COBRA-SFS Model and Results for NUHOMS-32PT Spent Fuel Storage Canister

Description of COBRA-SFS Model

Comparison of Transnuclear ANSYS model and COBRA-SFS Model of NUHOMS-32 PT

Figure 5. Illustration of parallel path $k_{eff-along 1}$ assumed in TN's ANSYS model for the XM-19 basket plate and assumed 0.0075" gas gap on either side

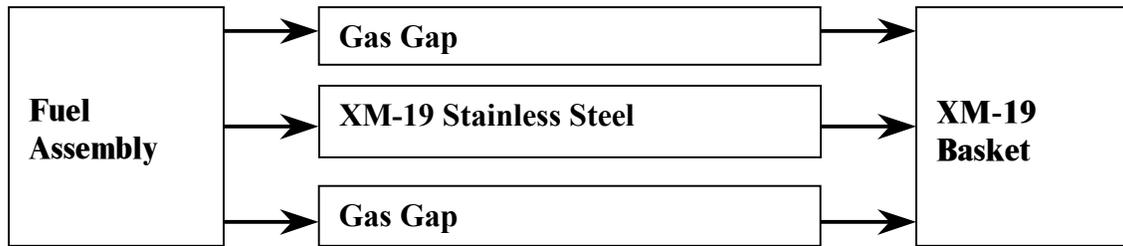
Figure 5 represents the heat transfer path as modeled in ANSYS by TN for heat flow from the fuel assemblies through the “gas gap+XM-19+gas gap” sandwich that only exists in select locations. After passing through this incorrectly assumed parallel path to an XM-19 node, heat transfer along the XM-19 material heading out radially to the canister wall is treated as simply conduction through the XM-19 material. Coincidentally, only one gas gap should have been assumed given TN’s selected modeling approach. Figure 6 represents the heat transfer path as modeled in ANSYS by TN for heat flow from the fuel assemblies through the L-shaped “aluminum+gas gap+Poison plate” sandwich that only exists in select locations. After passing through this incorrectly assumed parallel path, the heat flows into the XM-19 stainless basket material through another incorrectly assumed parallel path as depicted in Figure 5, then radially outward to the canister wall.

This approach can be used to represent only the heat flow paths along the layers of the plates and the path along the axial length of the canister. It is not an appropriate representation of the heat flow path along the continuous XM-19 stainless steel plates to the support rails,

which is the primary route of heat removal. Axial heat transfer, which can be represented with the effective thermal conductivity based on parallel-paths, is capable of removing only a small part of the heat from the canister. As such, bi-directional material property definitions are required in order to accurately specify the orthotropic nature of heat conduction through these components, given TN's geometric construction approach.

Shown in Figure 7 is a conceptual representation of these “radial” heat transfer paths through the basket. In no case can the heat flow be treated as following a parallel path (along the layers) exclusively, as described by Eq. (1) above. The effect of using a $k_{eff-along}$ defined as in Eq. (1) for heat transfer “through” the basket cell edges, gaps and ancillary components results in a significant overestimation of the effective thermal conductivity of the basket structure. Using the path featured in Figure 5 as an example, in this case for the direction passing through the left or upper wall of the “cell” depicted in Figure 3 involving helium, the applied effective thermal conductivity ($k_{eff-along 1}$) works out to be a little more than four times that which should have been applied ($k_{eff-through 1}$) as illustrated by the following calculations.

Inserting appropriate values for these thermal conductivities and using the specified dimensions of the various components yields a value for $k_{eff-along 1}$ that works out to be approximately 4.3 to 4.7 times larger than $k_{eff-through 1}$.

Figure 6. Illustration of parallel path $k_{eff-along 2}$ assumed in TN's ANSYS model for the L-shaped aluminum and neutron poison plates and the associated 0.00375" gas gap

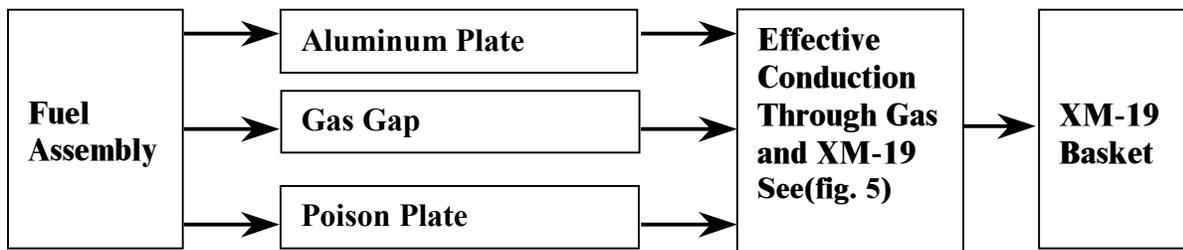
Making an example of the path featured in Figure 6, for the direction passing through the right or lower wall of the “cell” depicted in Figure 7, the applied effective thermal conductivity ($k_{eff-along 2}$), for the Al/neutron poison materials sandwiching the assumed 0.00375” gas gap (excluding the XM-19 and surrounding gap gas), works out to be around thirty times that which should have been applied ($k_{eff-through 2}$), as illustrated by the following calculations.

Values of $k_{eff-along 1}$ and $k_{eff-along 2}$ were applied in all directions in the ANSYS model supplied by TN, to define the effective thermal conductivity in the bodies representing 1) the basket material region and 2) the Al/neutron poison plate region. These material regions were not modeled in ANSYS with separate material orientation (orthotropic) and property definitions. Hence, the same values of $k_{eff-along 1}$ and $k_{eff-along 2}$ were applied in both the “along” and “through” directions.

It could be argued that this lumping of material properties is an appropriate representation for heat transfer through the basket material in the *axial* direction (from canister end to end), but it is obviously not correct in the radial direction involving “through” heat paths. Heat transfer must pass serially through the aluminum and neutron plates and associated gas gaps and then into and through the XM-19 stainless steel basket structure to travel out to the support rails.

Figure 9.
Figure 9.

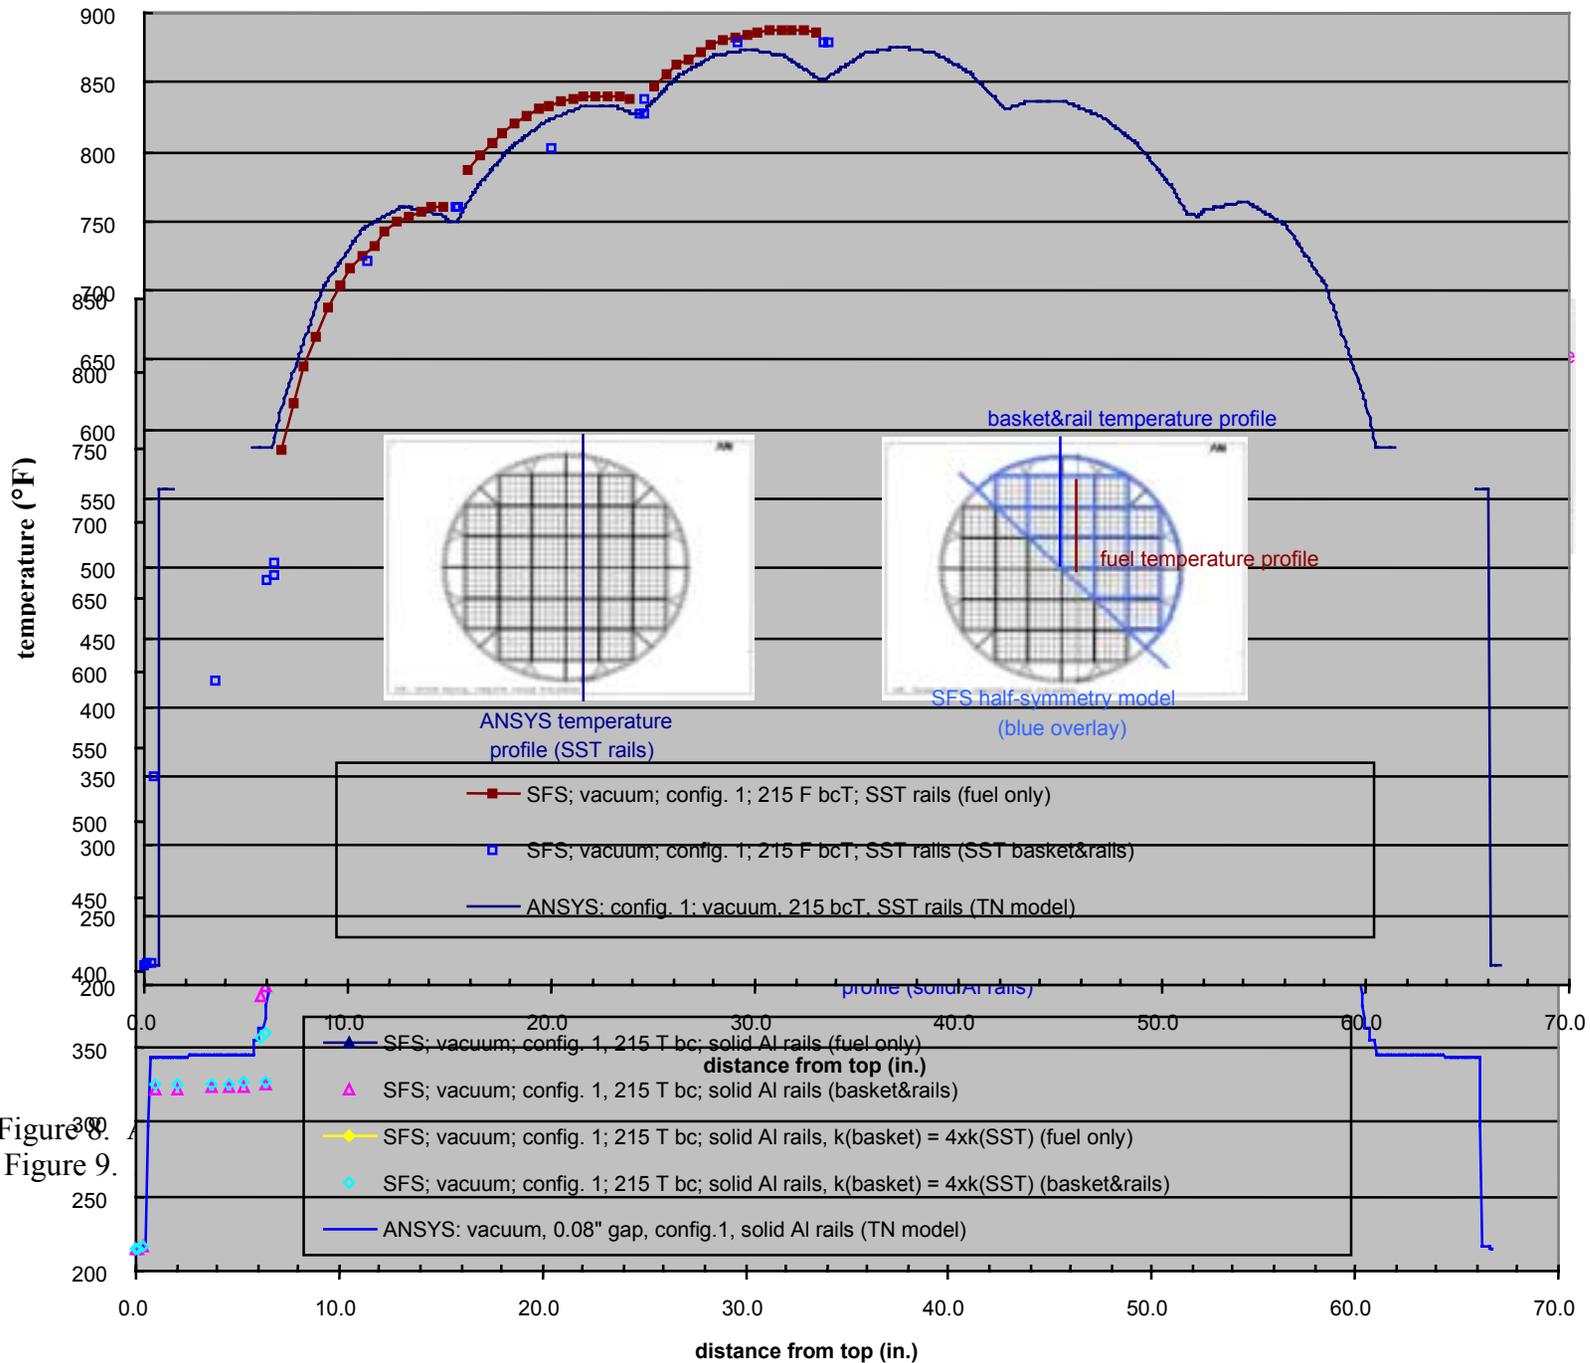
The profiles in Figure 9, comparing the ANSYS and COBRA-SFS results for vacuum conditions with the solid aluminum rails, further illustrate this problem. When the appropriate thermal conductivities are used in the basket and rail regions, as shown by the COBRA-SFS results, the peak clad temperature is 801 °F, more than 112 °F above the value of 713 °F predicted with the ANSYS model. COBRA-SFS results obtained with the thermal conductivity of the basket artificially enhanced to about four times that of stainless steel lower the predicted peak clad temperature to about 647 °F; approximately 155 °F lower than the peak temperature predicted for the same design with the thermal conductivity of the solid nodes of the basket modeled correctly. This result is lower than the ANSYS results by about 65 °F, mainly because the COBRA-SFS model does not include most of the conservative assumptions incorporated in the ANSYS model. (In general, COBRA-SFS is applied using 'best estimate' modeling assumptions, and will usually predict temperatures somewhat lower than conservative licensing calculations.) In this case, these results show how sensitive the peak clad temperature is to thermal properties of the basket material. When the canister is in vacuum, the dominant mode of heat transfer from the fuel to the basket is radiation, and heat moves through the basket to the rails almost exclusively by conduction through the stainless steel plates of the basket.

Figure 10.
Figure 11

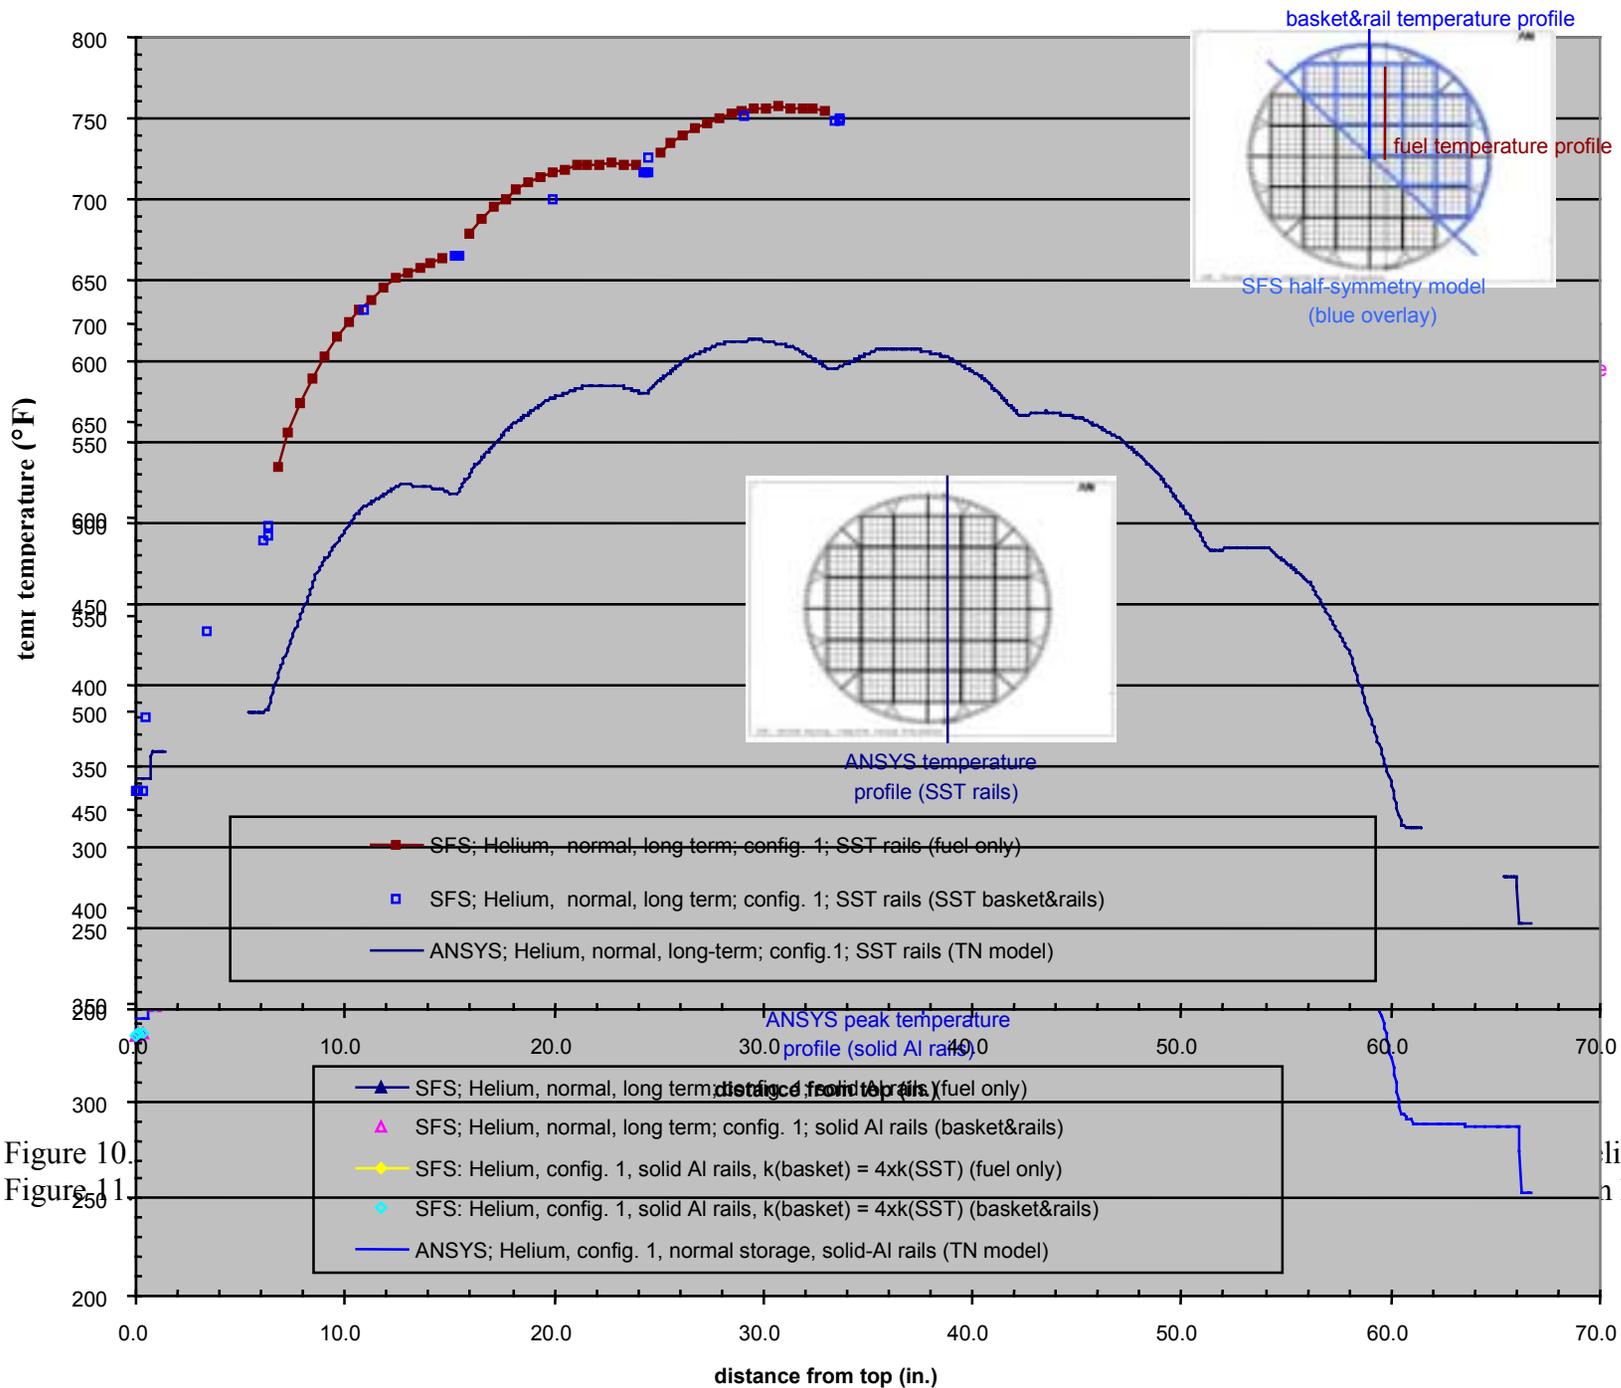
The profiles in Figures 10 and 11 show comparisons of ANSYS and COBRA-SFS predictions of temperature profiles for both the stainless steel and solid aluminum rail designs with helium as the fill medium rather than vacuum. These profiles show essentially the same thermal behavior and temperature trends as were noted for the vacuum case. The only significant difference is that the peak temperatures are somewhat lower, due to the relatively high thermal conductivity of helium in comparison to the thermal conductivity of the extremely attenuated air in the vacuum case.

Another discrepancy noted in the TN ANSYS model was the large difference in the peak clad temperatures predicted for the helium and vacuum cases for the stainless steel rail design. In the ANSYS calculations, the peak clad temperature for the vacuum case is 875 °F, and for the helium case it is only 613 °F; a difference of about 262 °F, in contrast to the difference of approximately 130 °F obtained in the COBRA-SFS calculations. This result is contrary to experimental data obtained in instrumented spent fuel canisters for a wide range of decay heat loads, geometric designs, and storage orientations, with backfill media that included air, helium, and vacuum storage. The increased effective thermal conductivity in the basket region (and in the rails, for the stainless steel rail design) results in a significant under prediction of the peak clad temperature in the ANSYS calculations. The results obtained in the TN ANSYS model do not appear to agree with published data.
